PHILADELPHIA ELECTRIC COMPANY
NUCLEAR GROUP HEADQUARTERS
955-65 CHESTERBROOK BLVD.
WAYNE, PA 19087-5691
(215) 640-6000

Subject: Limerick Generating Station, Unit 1 and Common
First Ten Year Interval Inservice Inspection (ISI) Program
Submittal of Relief Requests and Revised Edition of the
of the Program Plan Document

Limerick Generating Station
Unit 1 and Common
First Ten Year Interval
Inservice Inspection (ISI) Program
Relief Requests

Table RR-13-1.7

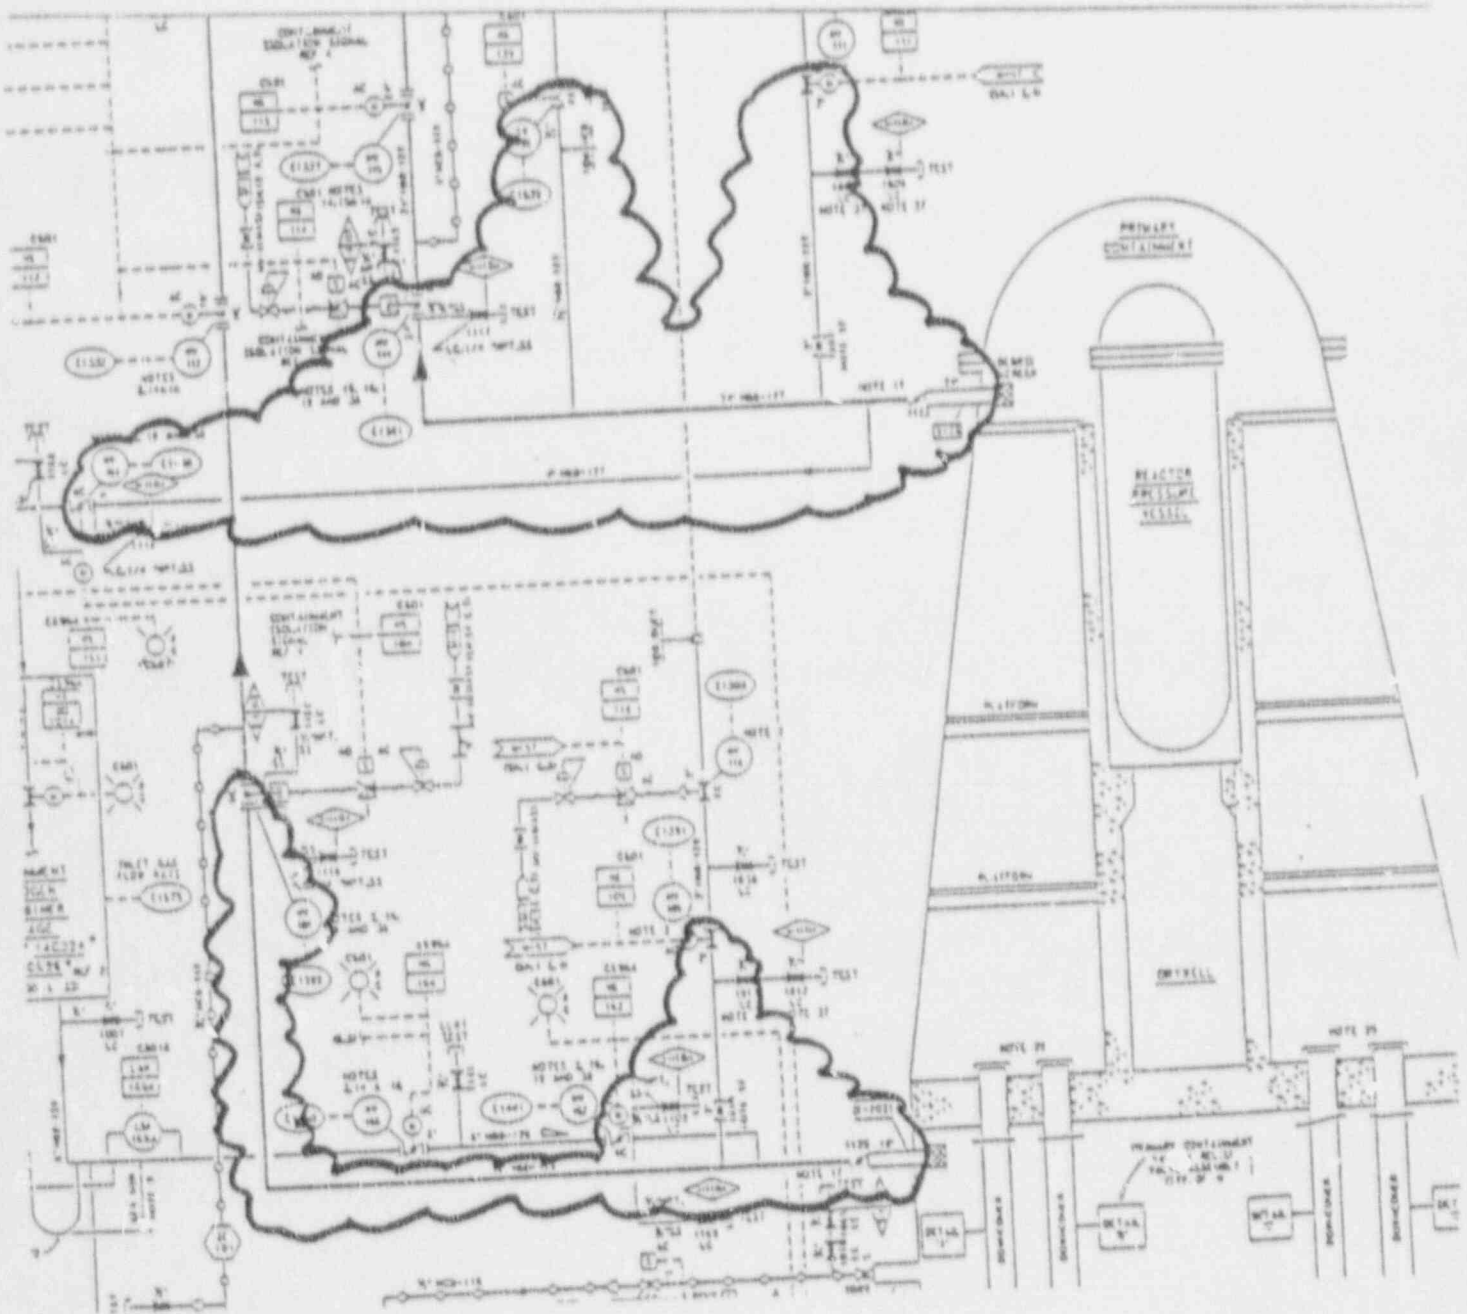
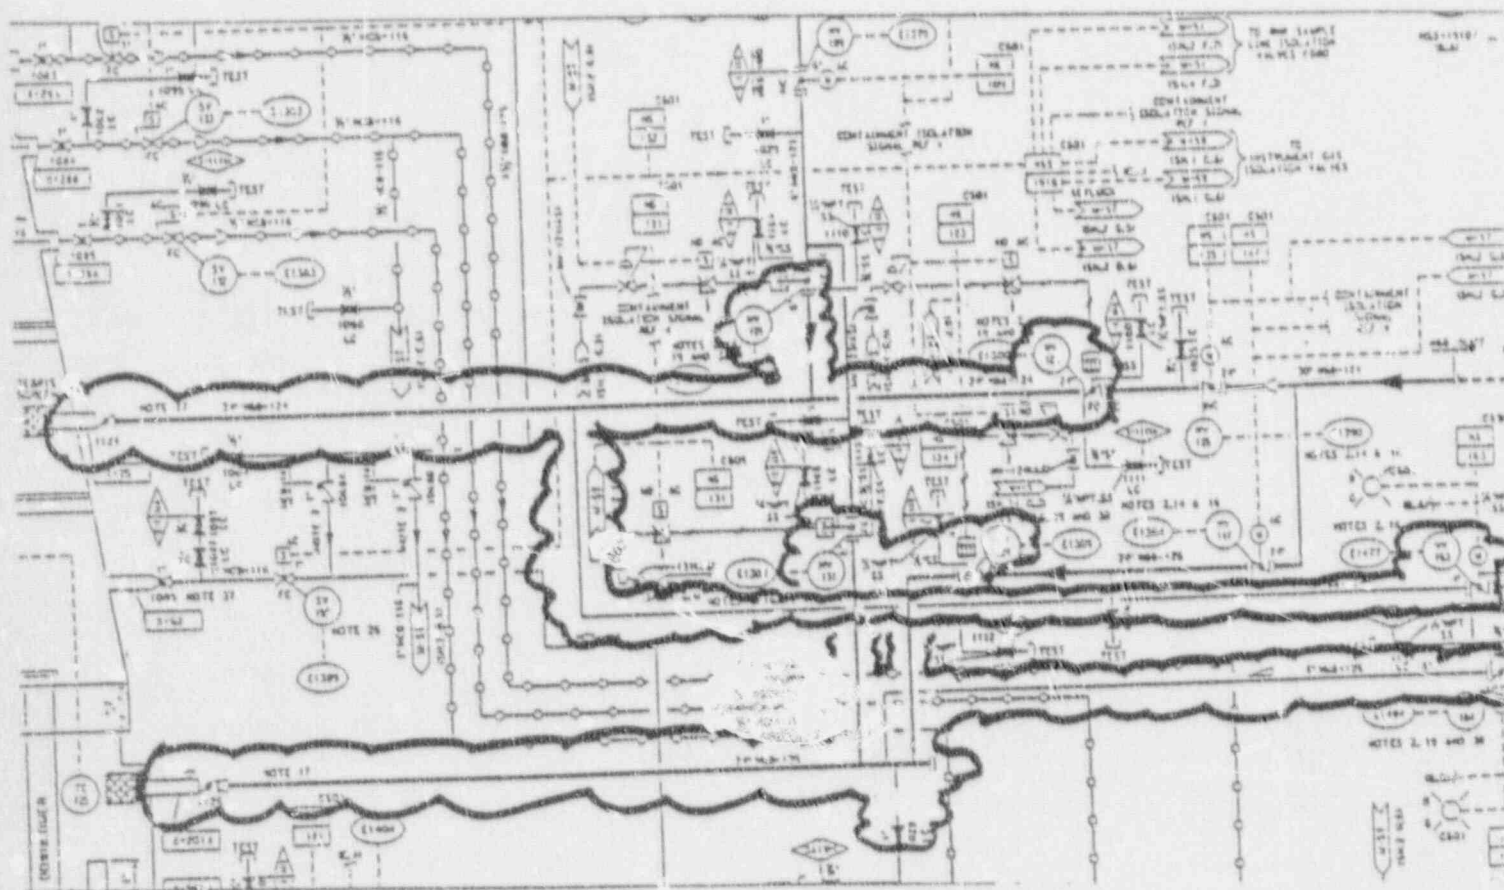
Class 2 Containment Atmospheric Control piping as illustrated in figures RR-13-1.7a, b.

IWC-5221, System pressure test during system functional/in-service tests and,
IWC-5222, System hydrostatic test.

10CFR50 Appendix J Local Leak Rate Testing (LLRT) meets the intent of the ASME requirement.

The LLRT offers the following advantages over system pressure tests:

- 1) LLRTs are performed more frequently than periodic system functional tests.
- 2) LLRTs have the ability to quantify leakage which is not feasible with VT-2 inspection on this essentially gas-filled piping.
- 3) LLRTs conservatively include through valve leakage which would not be identified in a VT-2 inspection.

IWC-5210(b) allows for air tests which permit location and detection of through-wall leakages. In the event the LLRT fails to meet its acceptance criteria, further testing would be performed to determine the location of the leaks, appropriate corrective maintenance and an appropriate retest would be performed.

10CFR50 Appendix J Local Leak Rate Testing (LLRT) will be utilized to meet the ASME Section XI IWC-5000 pressure testing requirements.
